Product Update

SER 15-005

SpiderLine THLL New vs. Legacy Component Mixing

May 21, 2015

New SpiderLine THLL: Red rectangle stanchions

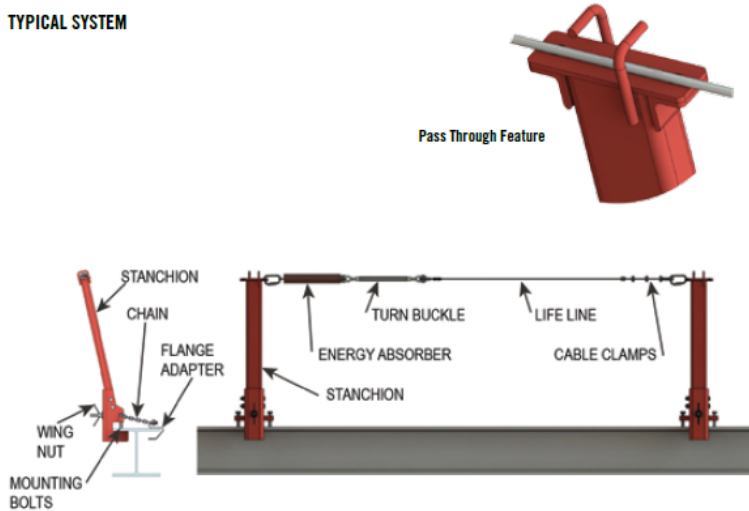
The **New** SpiderLine Temporary Horizontal LifeLine system (P/N 700783-XXX) meets the requirements of ANSI Z359-2007, CSA Z259.13-04, and OSHA, when the system is comprised exclusively of New SpiderLine components (708780-1 Post with related mountings; 709026-2 Energy Absorber & 708784 Cable) and is installed per instructions in Operators Manual 709025 and labels 709018-x and 709019-x. If a combination of **New** and **Legacy** SpiderLine (P/N P-XXXXX) components is used, the system meets OSHA requirements. If **New** or **Legacy** SpiderLine components are used in combination with components from **other manufacturers**, a Competent Person must determine if the system meets OSHA requirements.
